Planning stage structural report

150 Day Street

Prepared for UOL / 20th March 2025

Issue: Revision 2

1 L11 PLAN - TRANSFER FLOOR

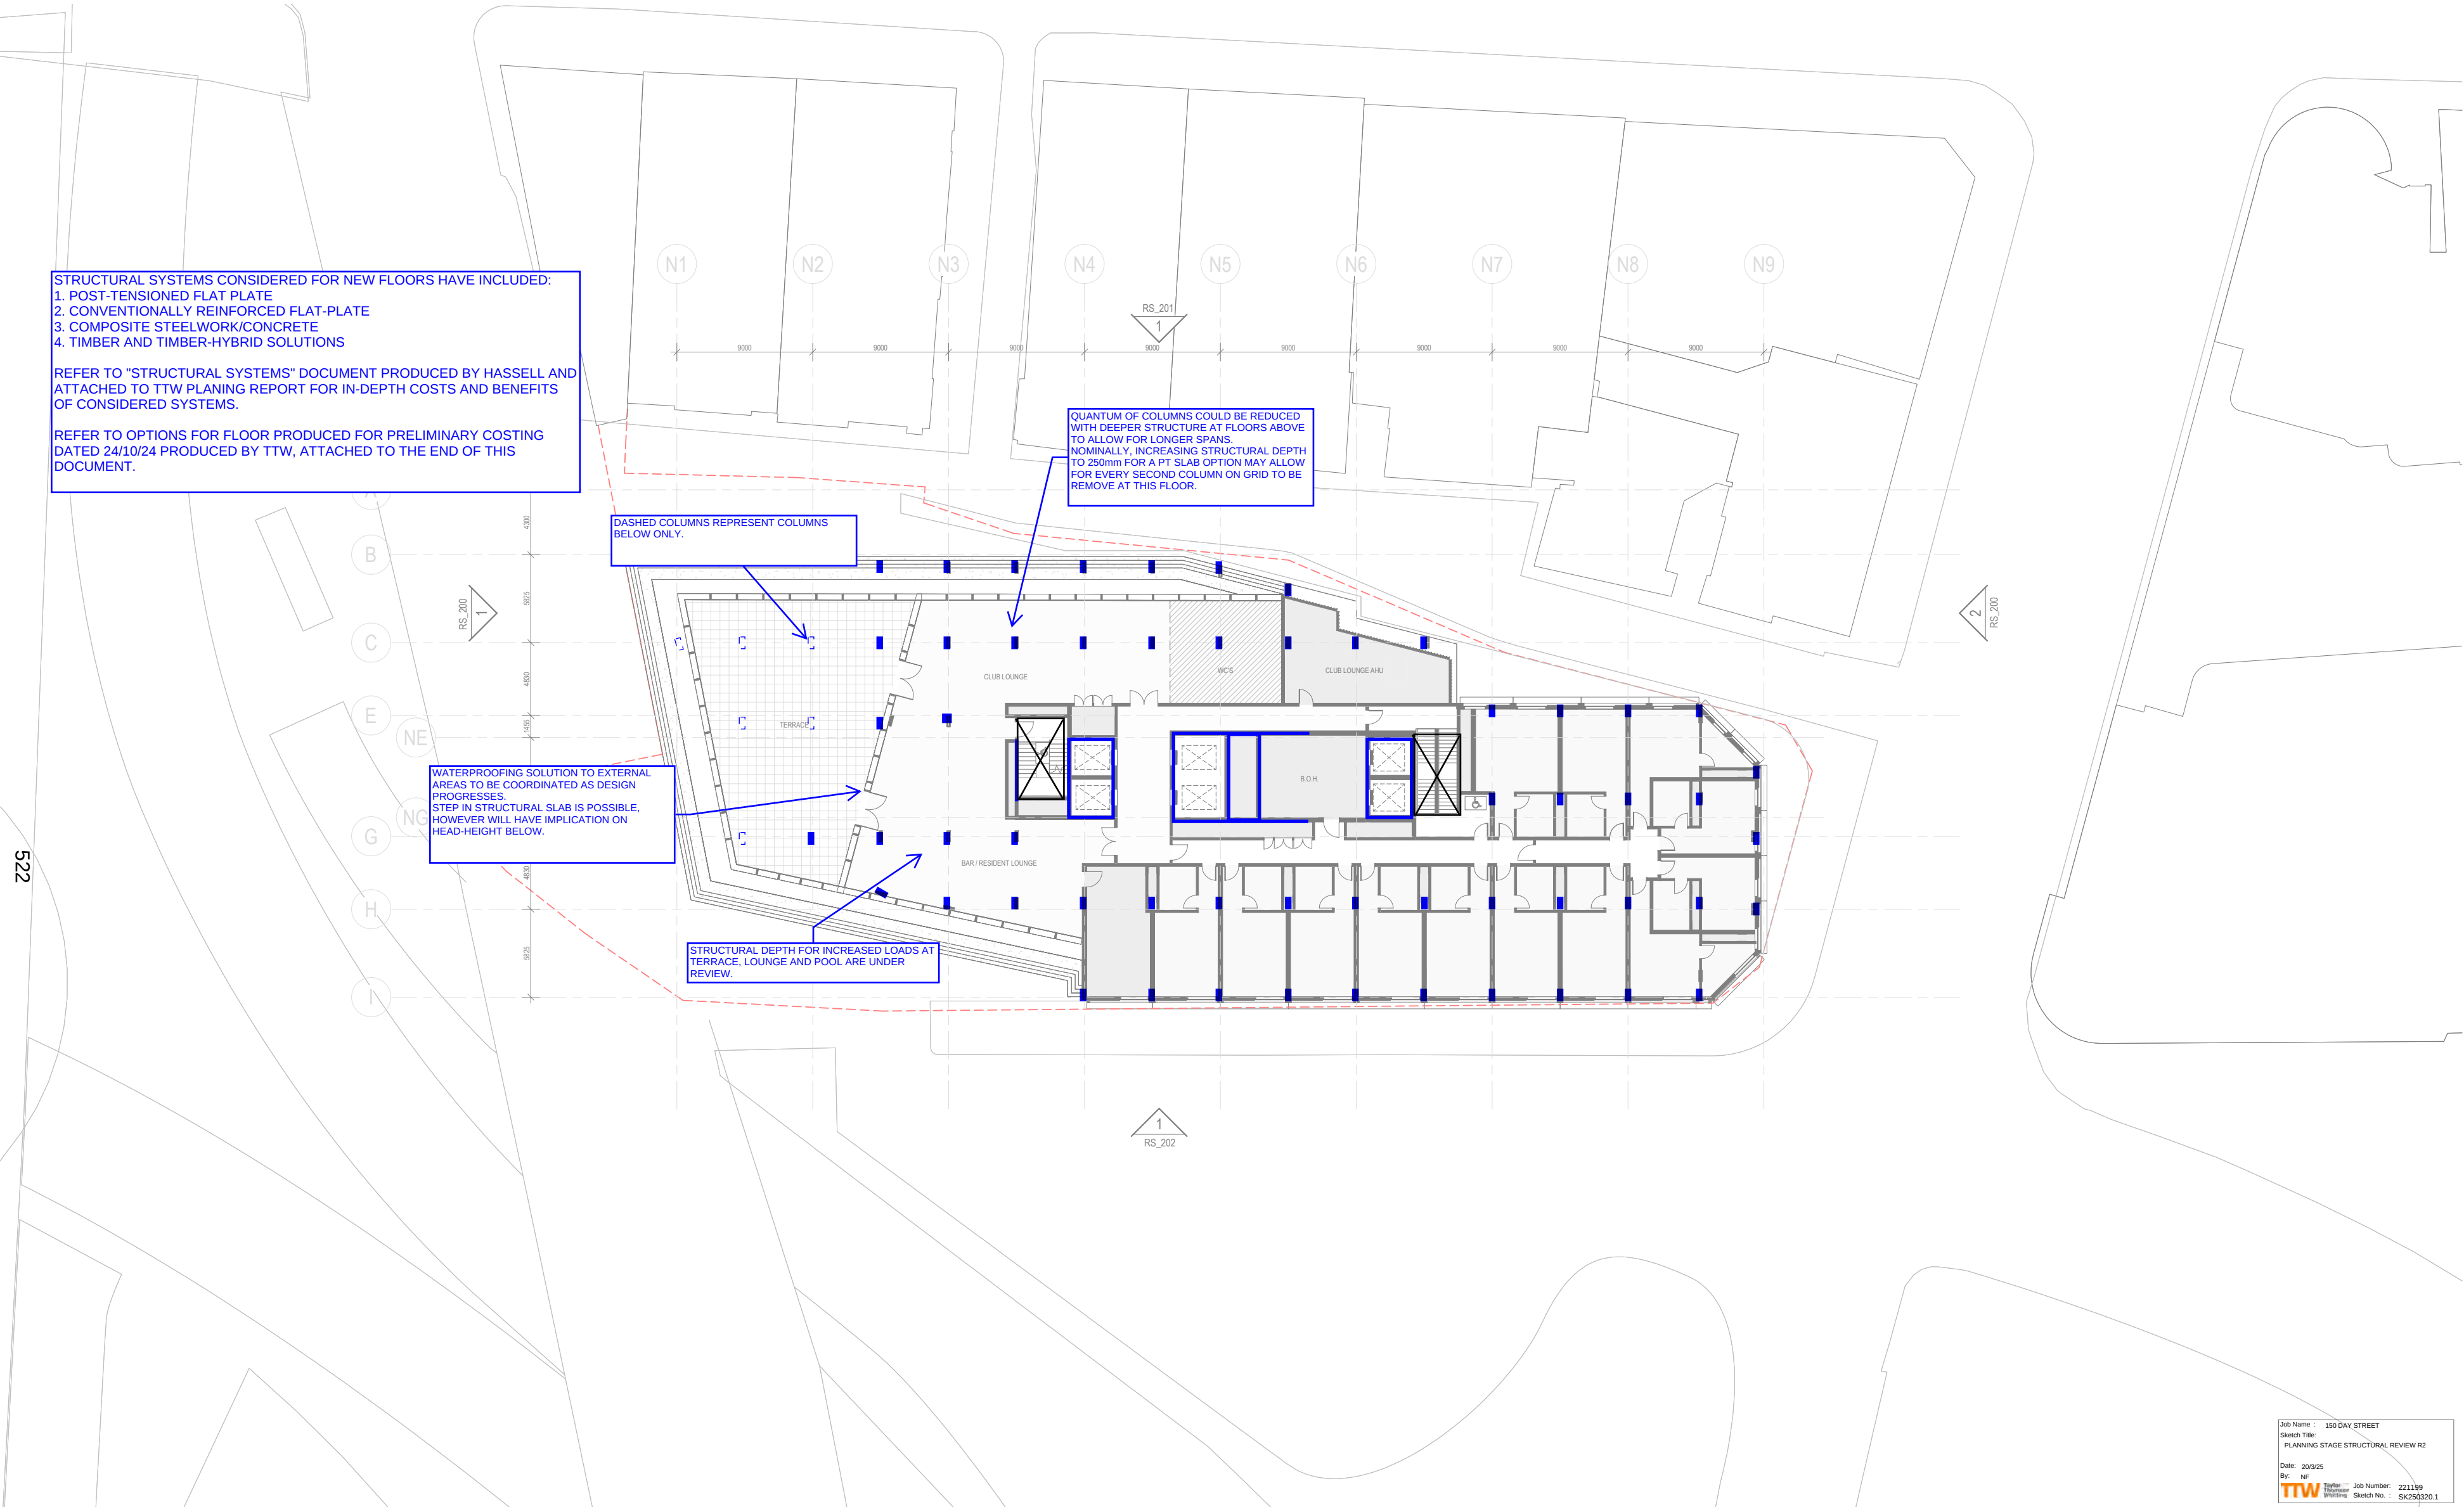
ALLOW FOR STRENGTHENING TO EXISTING L11 STRUCTURE TO FACILITATE CHANGE OF USE. STRENGTHENING MAY BE ACHIEVED BY A GRILLAGE OF BEAMS ABOVE THE EXISTING SLAB (HIDDEN WITHIN AN ACCESS FLOOR) TO SUPPORT THE WEIGHTS OF PLANT, LANDSCAPE AND POOL LOADS.

THIS STRENGTHENING COULD BE INCORPORATED INTO A CONSTRUCTION CRASH DECK WHICH WOULD BE INSTALLED TO ALLOW FOR CONSTRUCTION OF THE ADDITIONAL STOREYS WHILE ACCESS IS MAINTAINED BELOW FOR MODIFICATION AND FIT-OUT WORKS,

NOTE ON HEAVY PLANT EQUIPMENT
HEAVY PLANT WILL REQUIRE STEEL GRILLAGE AT LOW LEVEL FOR STRUCTURAL SUPPORT IN ORDER NOT TO OVERLOAD EXISTING SLAB.
GENERAL INTENTION IS TO PROVE AND ACCESS FLOOR OVER LOW-LEVEL STEEL BEAM GRILLAGES.

STRUCTURAL REVIEW ON EIGHTS OF PLANT, INCLUDING PLINTHS, MUST BE CARRIED OUT TO EXISTING STRUCTURE IS NOT OVERLOADED.
HEAVY PLANT SHOULD BE LOCATED CLOSE TO STRUCTURAL SUPPORTS (COLUMNS) AND LIGHT-WEIGHT PLINTHS SPECIFIED TO MINIMISE STRENGTHENING REQUIREMENTS.

AT BUILDING PERIMETER, COLUMN TRANSFER COULD BE ACHIEVED BY TRUSSES, OR BY DEEP STRUCTURE, POTENTIALLY HIDDEN WITHIN THE DEPTH OF THE PROPOSED PLANTER BEDS.

STRUCTURAL REQUIREMENTS TO SUPPORT WEIGHT OF POOL PLANT MUST BE REVIEWED IN DETAIL WITH INPUT FROM A POOL CONSULTANT.

IN GENERAL, WE WOULD EXPECT THAT A POOL CONSULTANT BE ENGAGED IN ORDER TO PROVIDE SPECIALIST ADVICE REGARDING PLANT, SPATIAL LAYOUTS AND REQUIREMENTS FOR BALANCE TANKS.

GENERAL STRUCTURAL SOLUTION TO PROVIDE FULL STOREY STEEL TRUSSES TO TRANSFER COLUMN LOADS AT THIS STOREY.

NOTE ON PROPOSED USE OF GYM AREA
GENERALLY ALLOW FOR SUB-FLOOR OR ACCESS FLOOR WITHIN GYM AREA TO MINIMISE IMPACT OF VIBRATION PROPAGATION THROUGH STRUCTURE.

NOTE ON DEEP PLANTER ZONE AND INTEGRATED TEMPORARY WORKS DECK AT L11
INCLUSION OF DEEP PLANTER ZONE AT L11 WILL REQUIRE EXTENSIVE STRENGTHENING OF EXISTING STRUCTURE DUE TO INCREASED WEIGHT.

1 L22 PLAN - PLANT
RS_200 1:200

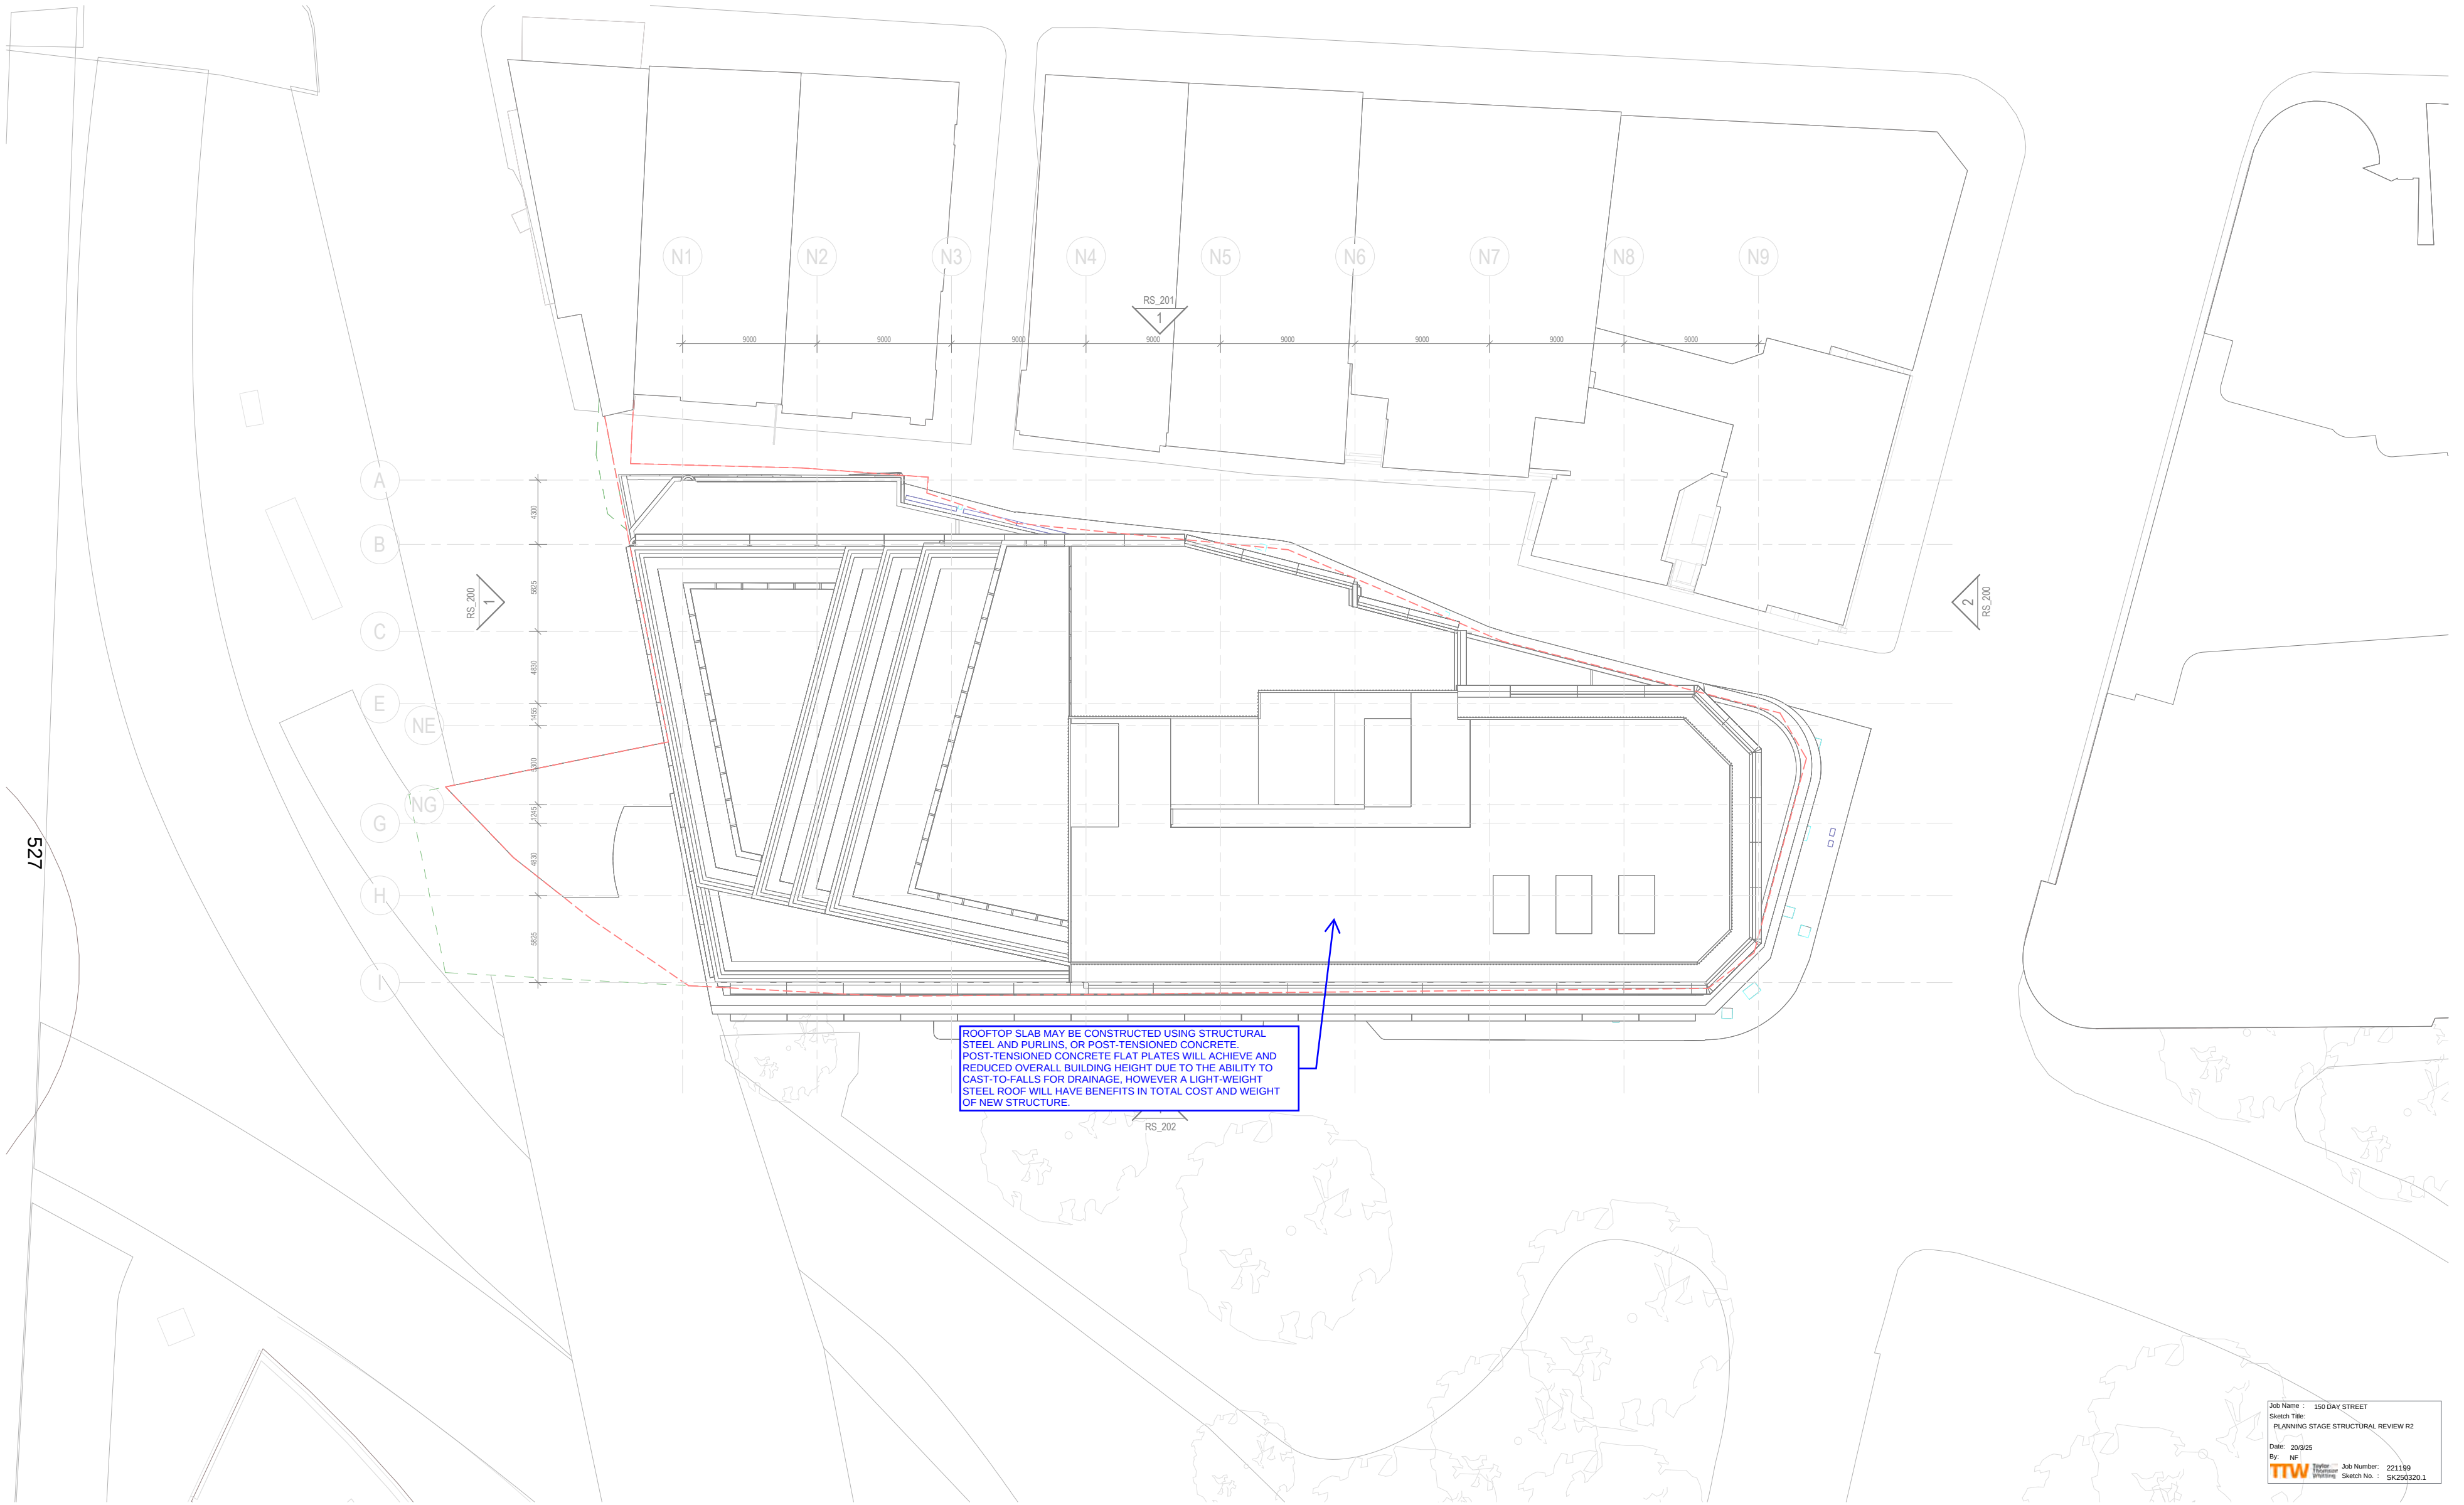
STRUCTURAL SYSTEMS CONSIDERED FOR NEW FLOORS HAVE INCLUDED:
1. POST-TENSIONED FLAT PLATE
2. CONVENTIONALLY REINFORCED FLAT-PLATE
3. COMPOSITE STEELWORK/CONCRETE
4. TIMBER AND TIMBER-HYBRID SOLUTIONS

IN GENERAL, IT IS EXPECTED THAT A POST-TENSIONED CONCRETE SOLUTION WILL LEAD TO A ROBUST SOLUTION FOR THIS SLAB. ITEMS TO BE COORDINATED AS DESIGN PROGRESSES INCLUDE:

1. FALLS AND IMPLICATIONS ON STRUCTURAL BUILD-UP.
2. DETAILED WEIGHTS OF PLANT AND WATER TOWERS TO ENSURE COLUMN STRENGTHENING IS ADEQUATE AT EXISTING STRUCTURE.
3. REQUIREMENTS FOR ACOUSTIC SCREENING AND SUPPORT OF ANY OTHER SCREENS
4. REQUIREMENTS FOR PLINTHS FOR PLANT AND ASSOCIATED WEIGHTS.
5. PLANT REPLACEMENT STRATEGIES AND ANY STRUCTURAL IMPLICATIONS.

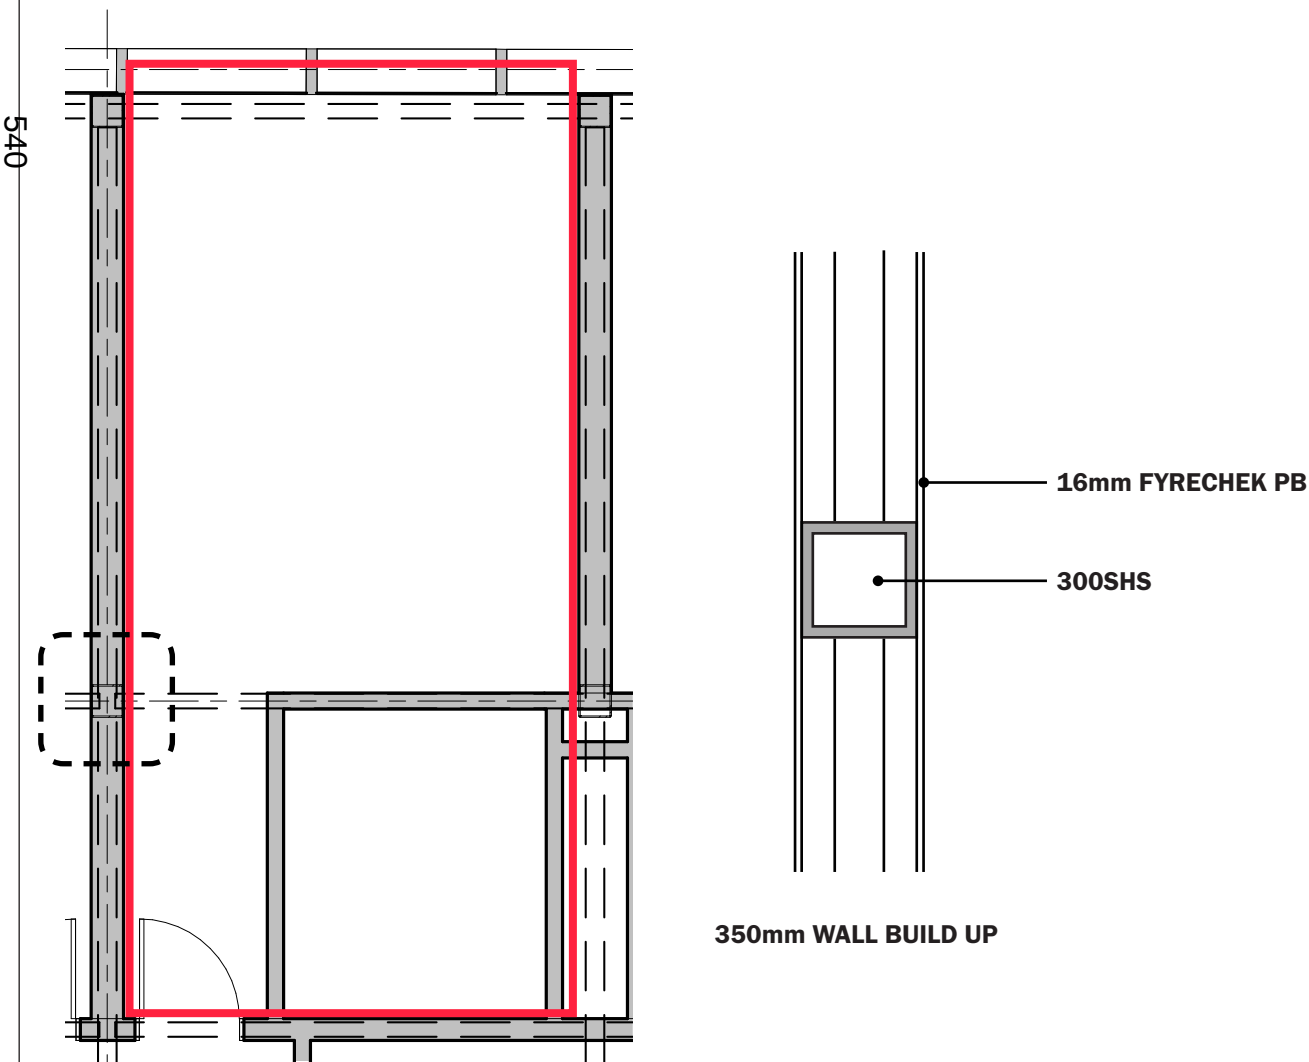
PROBLEM: WHERE NO HOTEL ROOMS, DEEPER BEAM = LIMITS FLEXIBILITY AND CEILING HEIGHTS WHEN NOT FOLLOWING ROOM GRID
